CHANGE REQUEST

⌘ **24.008 CR** ⌘ rev **-** ⌘ Current version: **3.6.0** ⌘

Title:	⌘ Modification to MS's MM states to enable LCS signalling on RR layer		
Source:	⌘ Nokia		
Work item code:	⌘ LCS	Date:	⌘ 07.03.2001
Category:	⌘ A	Release:	⌘ R99
	Use <u>one</u> of the following categories: F (essential correction) A (corresponds to a correction in an earlier release) B (Addition of feature), C (Functional modification of feature) D (Editorial modification)		Use <u>one</u> of the following releases: 2 (GSM Phase 2) R96 (Release 1996) R97 (Release 1997) R98 (Release 1998) R99 (Release 1999) REL-4 (Release 4) REL-5 (Release 5)
	Detailed explanations of the above categories can be found in 3GPP TR 21.900.

Figure 4.1a / GSM 04.08: Overview mobility management protocol / MS Side

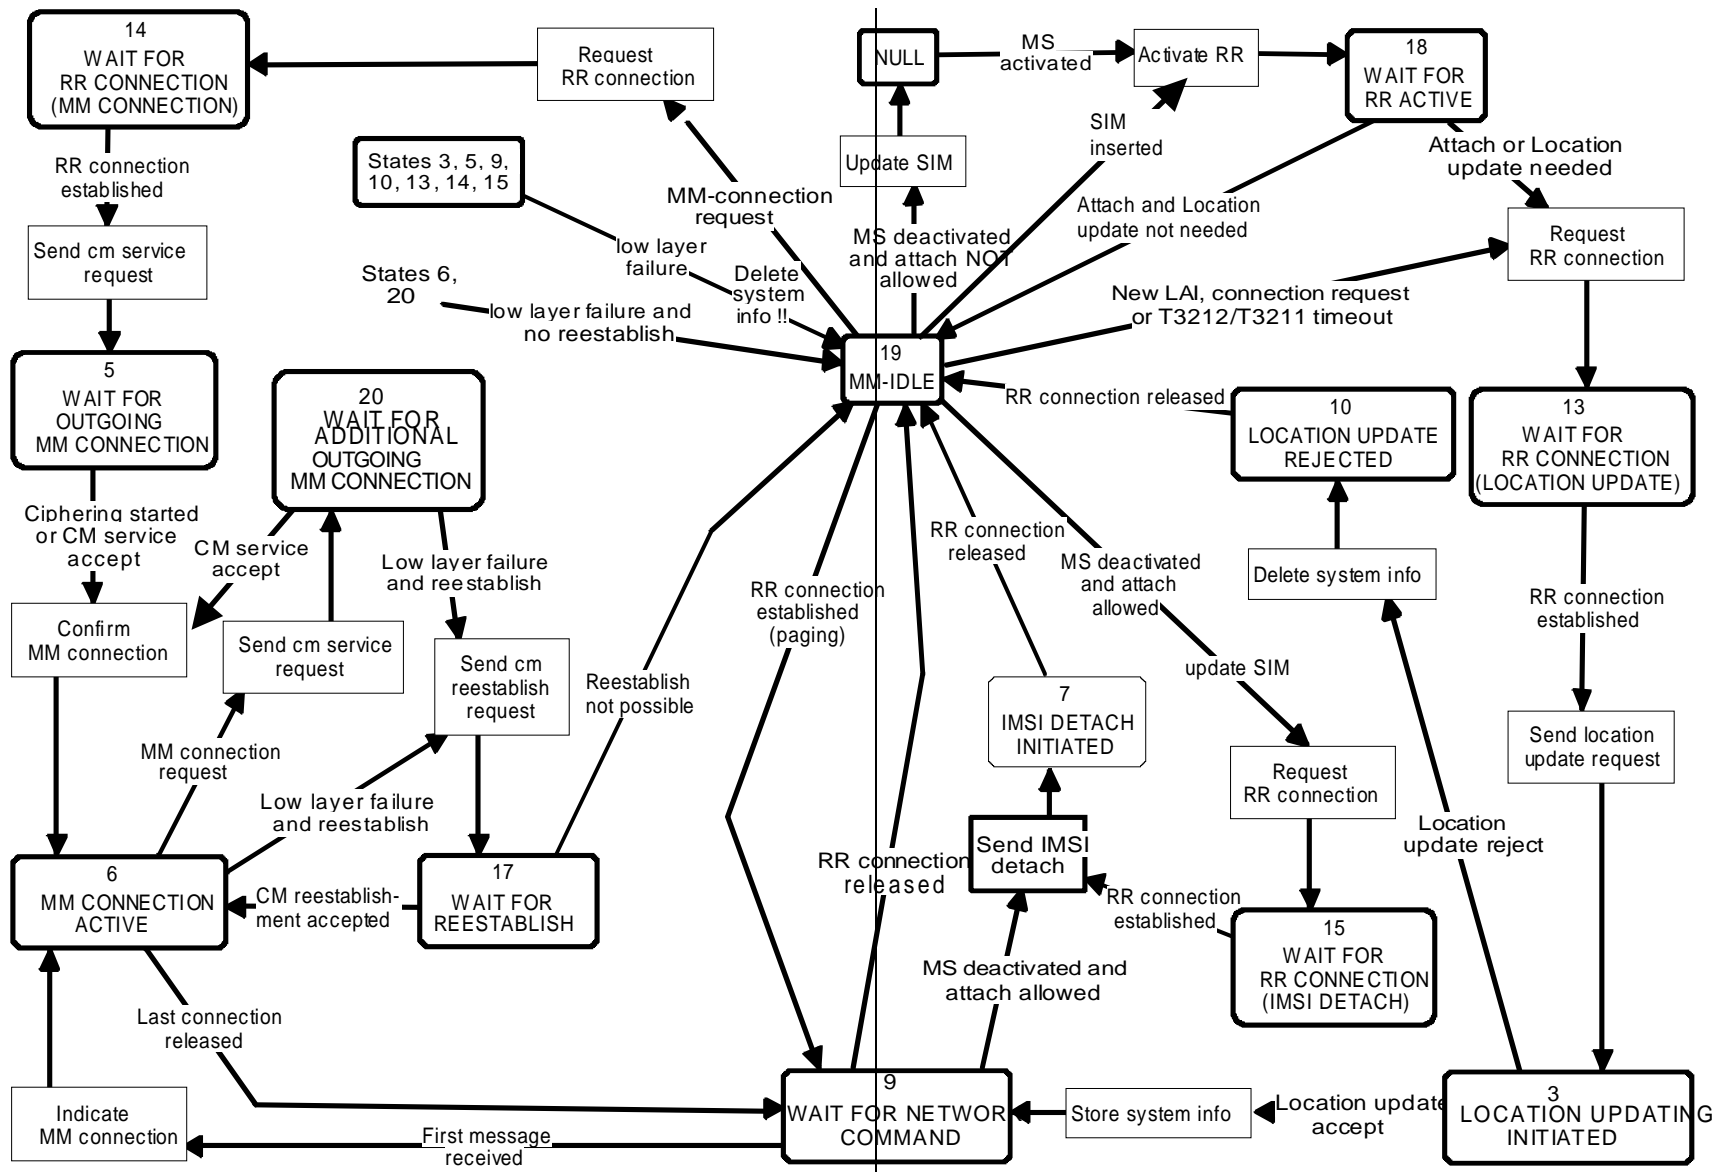
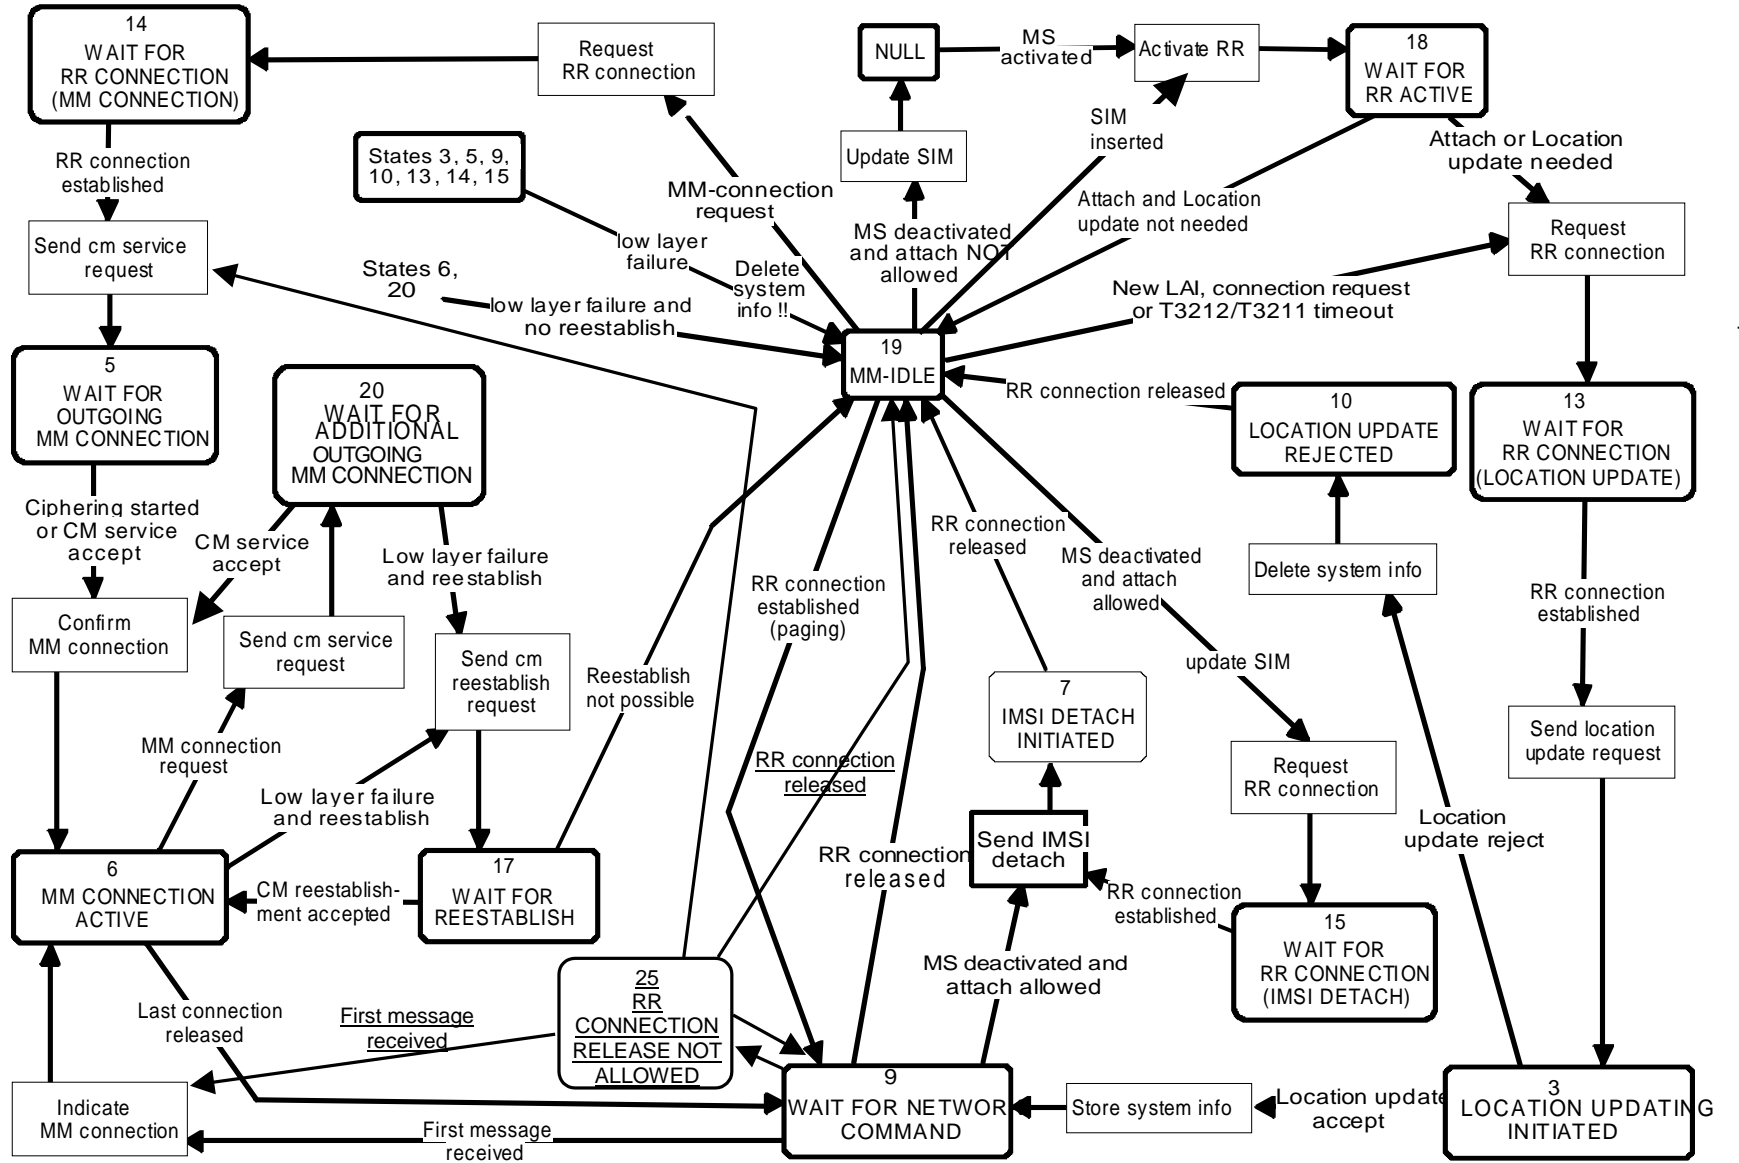
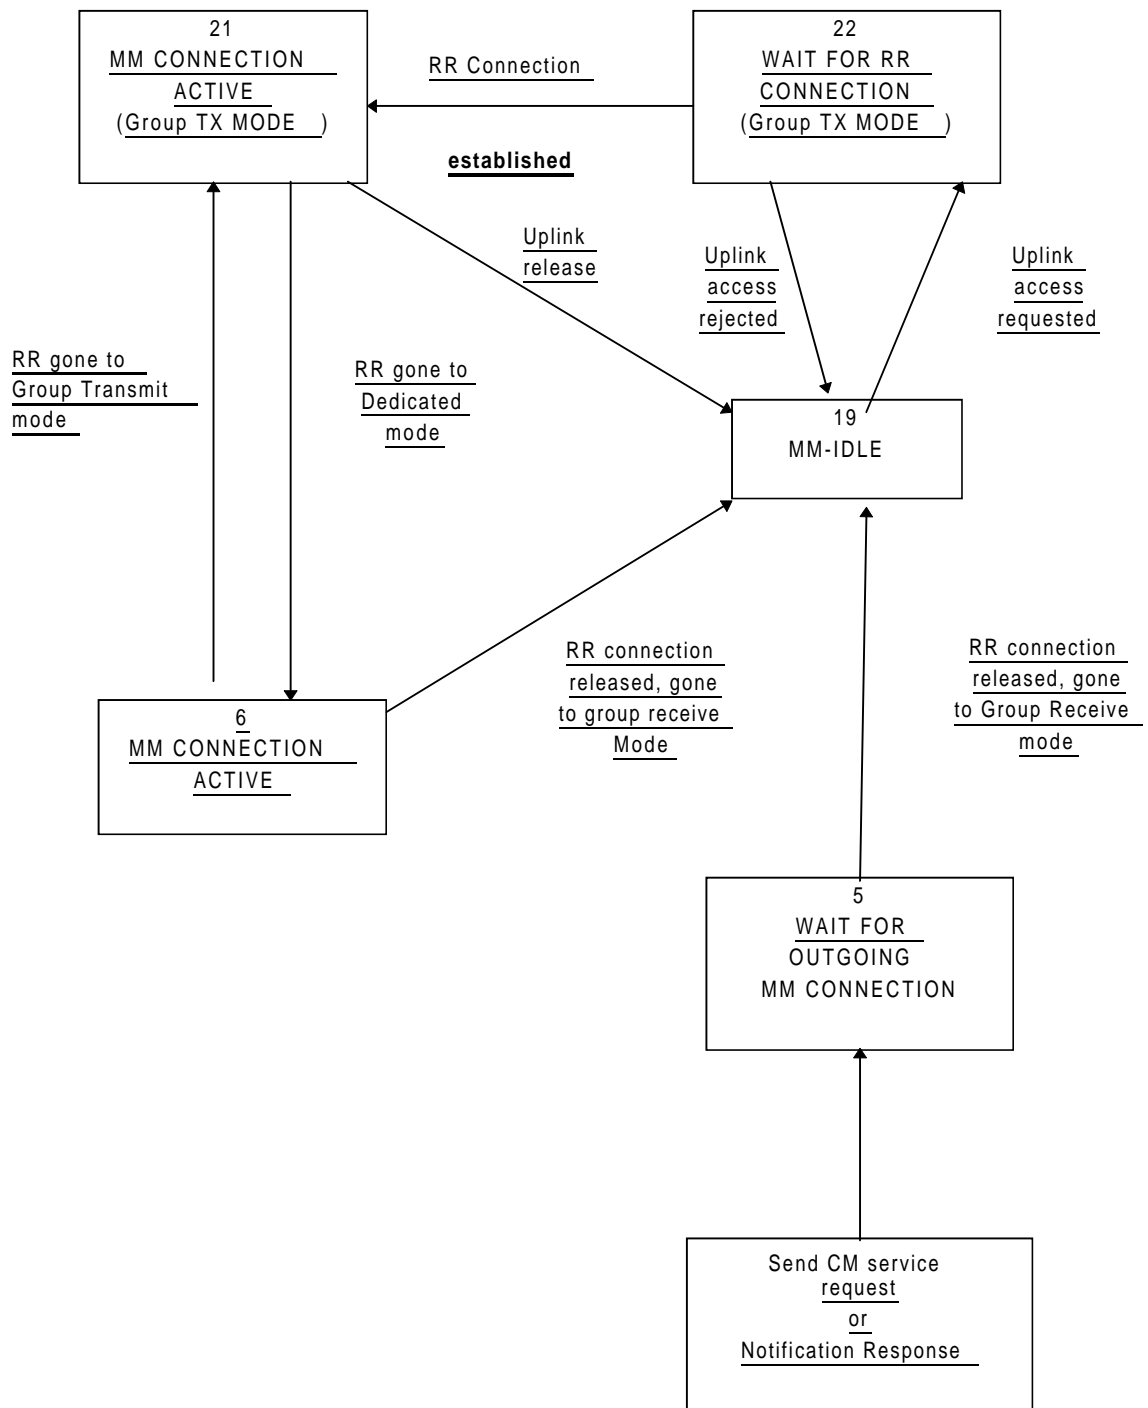
Additions to Figure 4.1.a/GSM 04.08

25. RR CONNECTION RELEASE NOT ALLOWED

(Only applicable for MSs supporting LCS) There is no MM procedure running but RR connection exists. The timer T32xx is running.
